10 Mb/s Single Twisted Pair Ethernet 10BASE-T1L Receive State Diagram (Comment #577)

Steffen Graber
Pepperl+Fuchs

10BASE-T1L Receive State Diagram

- The DECODE function in the current draft D2.0 is defined as:

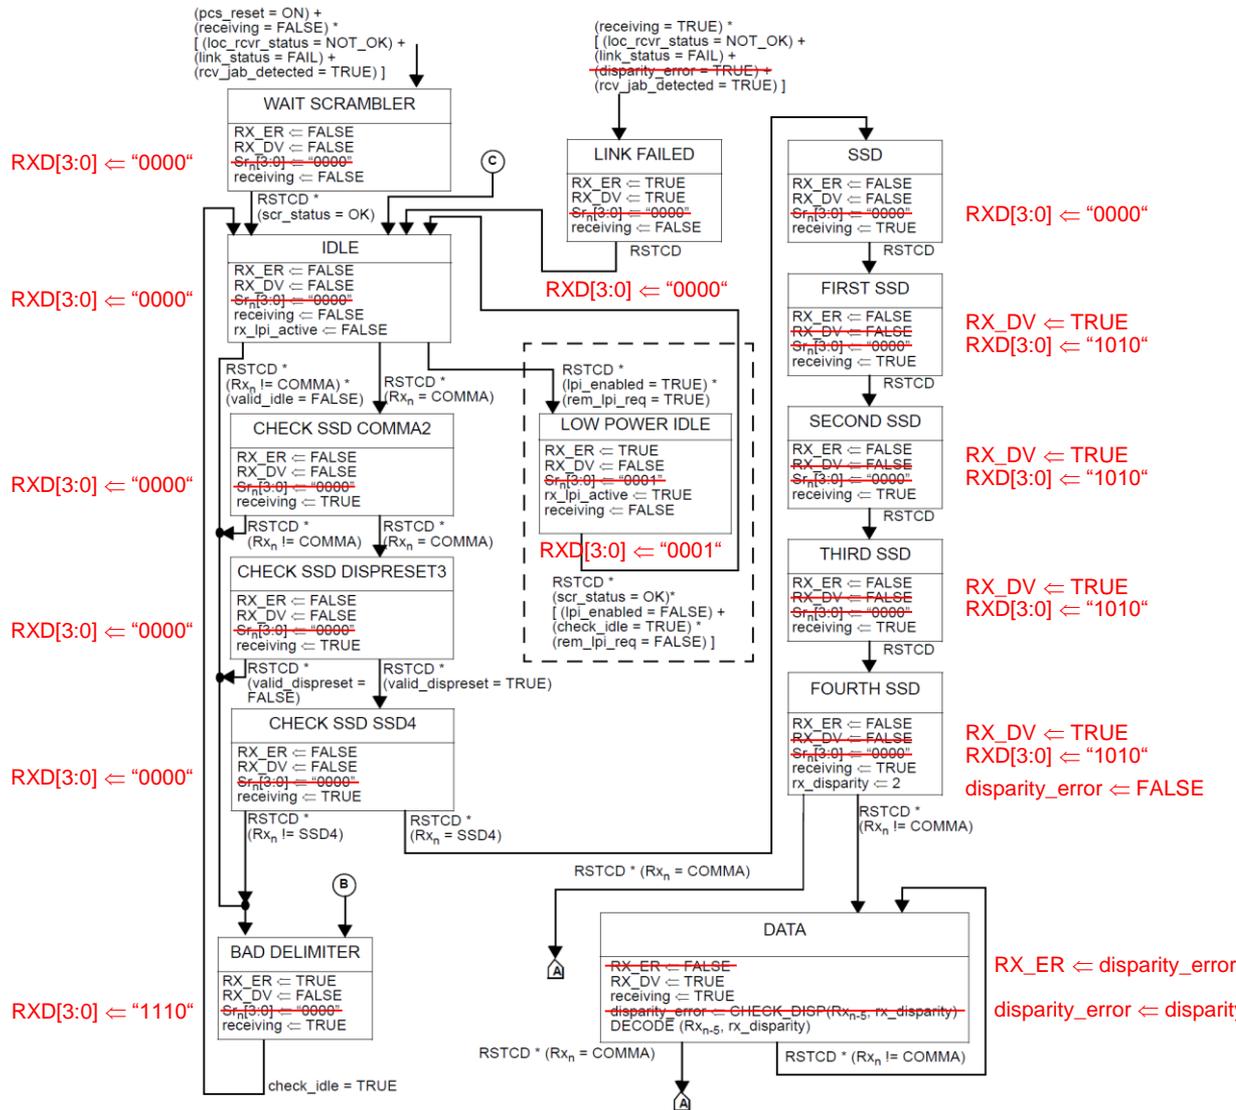
- The descrambler is currently sitting outside the decode function of the receive state machine.
- Therefore the Receive state diagram currently returns the scrambled receive data $Sr_n[3:0]$ instead of the descrambled receive data $RXD[3:0]$ as in other standards.

- Returning $Sr_n[3:0]$ instead of $RXD[3:0]$ has several disadvantages:
 - Signaling “Assert LPI” on the MII, requires to return $RXD[3:0] = “0001”$, which currently is not possible.

- The preamble currently cannot be recovered and is shortened, which is preventing back-to-back PHY configurations.
 - Being in “BAD DELIMITER” state cannot return a „False Carrier indication“ and $RXD[3:0]$ will be undefined.

- Due to descrambling of the data before going to the MII, being in “LOW POWER IDLE” or “BAD DELIMITER” state can return wrong status information to the MII (not indicating an “Assert LPI” condition or a “False Carrier indication” correctly).

- Detecting a disparity error currently is resetting the Receive state machine, going to „LINK FAILED“ state.
 - Just setting RX_ER would provide a „less aggressive“ behavior, but still allows to detect disparity errors.

- In this case reception continues, until an ESD or ESD with Error is received.

- The following steps are taken to solve the previously mentioned issues:

$$Sr_n[3:0] = \text{inverse}_{table_{4B3T}}(Rx_n)$$

- Including the descrambler functionality it needs to be changed to:

$$RXD[3:0] = \text{descramble}(\text{inverse}_{table_{4B3T}}(Rx_n))$$

- These changes allow to output RXD[3:0] instead of Sr_n[3:0] and therefore support to provide the correct LPI encoding “0001” on the MII.
- In „BAD DELIMITER“ state RXD[3:0] is encoded as „1110“, which is a „False Carrier indication“.
- Additionally the part of the preamble being replaced by the SSD is now recovered, allowing back-to-back PHY configurations, as the preamble is not shortened anymore.
- A detected disparity error is not completely resetting the state machine anymore, going to state „LINK FAILED“, but just setting RX_ER, which is a „less aggressive“ behavior, but still allows to detect disparity errors.

Changes (in red) to:
Figure 146-8 – PCS receive
state diagram (part a)

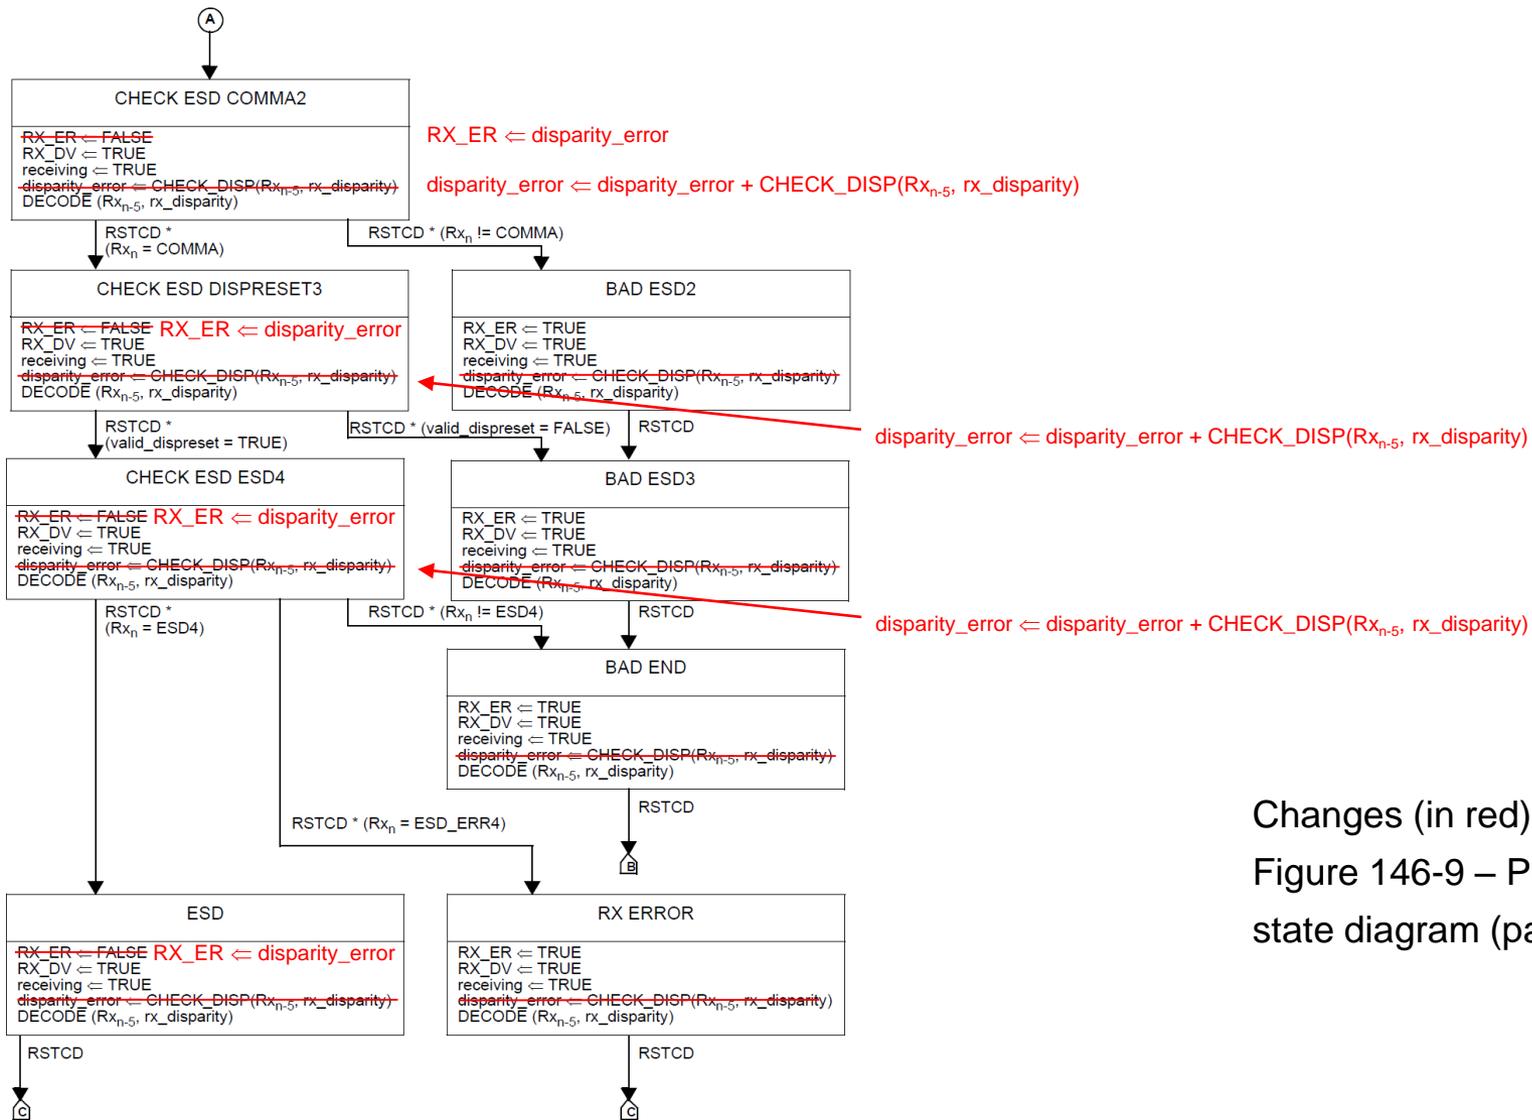
- Additionally the changes provided on the next two pages are proposed to be done:
